SERVICE INSTRUCTION

Introduction of new exhaust system components and assemblies for ROTAX® 912 (Series) and 912 i (Series) Aircraft Engines

ATA System: 78-10-00 Exhaust System

Fig. 2

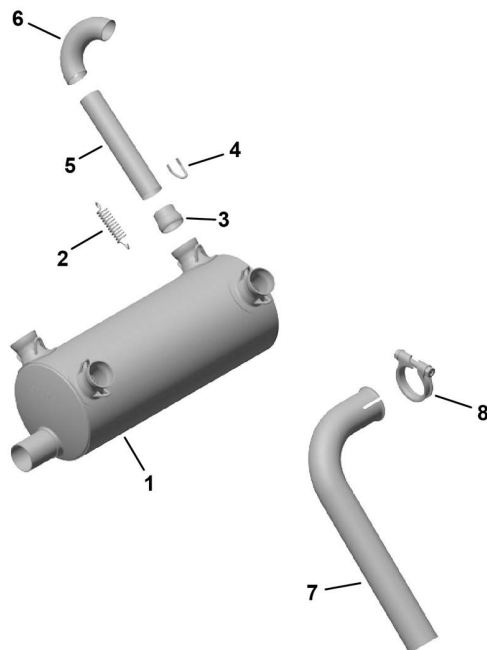
Fig.no.	New part no.	Qty/ engine	Description	Old part no.
2	978489	(1)	EXHAUST ASSORTMENT STAINLESS STEEL	978488
Consists of:				
2-1	978064	1	MUFFLER ASSY. STAINLESS	978063
2-2	938796	8	SPRING 66 MM STAINLESS	
2-3	978521	4	BALL JOINT MALE STAINLESS	
2-4	853356	8	HOOK STAINLESS	
2-5	978998	2	EXHAUST TUBE 800 MM STAINLESS	
2-6	978500	2	EXHAUST ELBOW ASSY. 360 DEGR. STAINLESS	
2-7	978605	1	EXHAUST ELBOW STAINLESS (TAILPIPE)

Muffler assy. 978064/978063 (0° bend angle) is for use with 80 HP engine only! Do not use on 100 HP engine.

Fig. 3 912 UL, ULS, iS (Series)

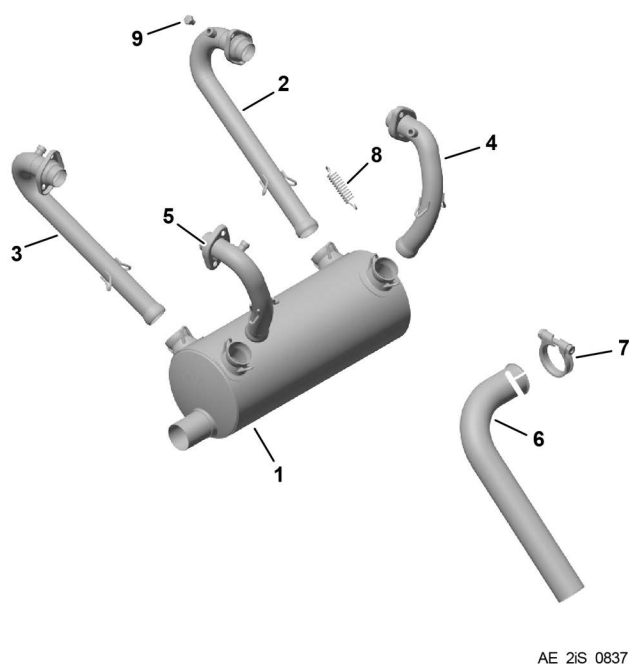
Fig.no.	New part no.	Qty/ engine	Description	Old part no.
3	973383	(1)	EXHAUST ASSORTMENT STAINLESS STEEL	973380
Consists of:				
3-1	973388	1	MUFFLER ASSY.	973385
3-2	973013	1	EXHAUST PIPE ASSY. CYL. 1	973010
3-3	973023	1	EXHAUST PIPE ASSY. CYL. 2	973020
3-4	973033	1	EXHAUST PIPE ASSY. CYL. 3	973030
3-5	973043	1	EXHAUST PIPE ASSY. CYL. 4	973040
3-6	973389	1	EXHAUST ELBOW STAINLESS (TAILPIPE)	973390
3-7	951552	1	EXHAUST PIPE CLAMP ASSY. 42 MM	951550
3-8	938796	9	SPRING 66 MM STAINLESS	
3-9	841115	4	HEX. SCREW M8X1X10

Muffler assy. 973388 has a tailpipe diameter of 42 mm and a bend angle of 0°, use with 973389 elbow (90° bend angle). Muffler assy. 973385 has a tailpipe diameter 40 mm and a bend angle of 3°, use with 973390 elbow (93° bend angle).

Fig. 4

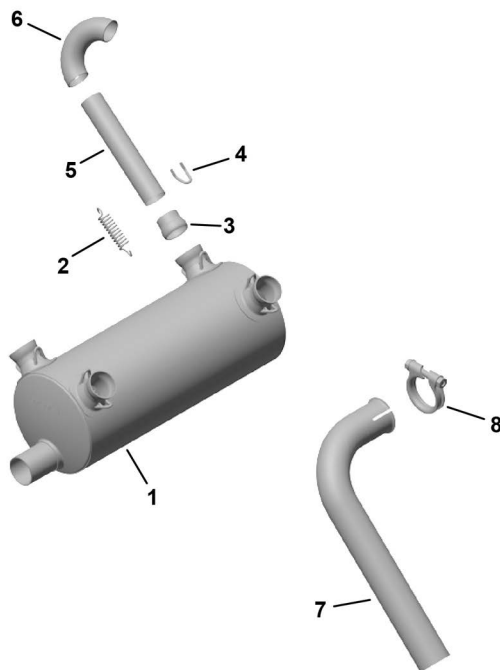
Fig.no.	New part no.	Qty/ engine	Description	Old part no.
4	973677	(1)	EXHAUST ASSORTMENT STAINLESS STEEL	973676
Consists of:				
4-1	973673	1	MUFFLER ASSY. STAINLESS	973674
4-2	938796	8	SPRING 66 MM STAINLESS	
4-3	978521	4	BALL JOINT MALE STAINLESS	
4-4	853356	9	HOOK STAINLESS	
4-5	978998	2	EXHAUST TUBE 800 MM STAINLESS	
4-6	978500	2	EXH.ELBOW ASSY. 360 DEGR. STAINLESS	
4-7	973389	1	EXHAUST ELBOW STAINLESS (TAILPIPE)	978605
4-8	951552	1	EXHAUST PIPE CLAMP ASSY. 42 MM	951550

Muffler assy. 973673 has a tailpipe diameter of 42 mm and a bend angle of 0°, use with 973389 elbow (90° bend angle).
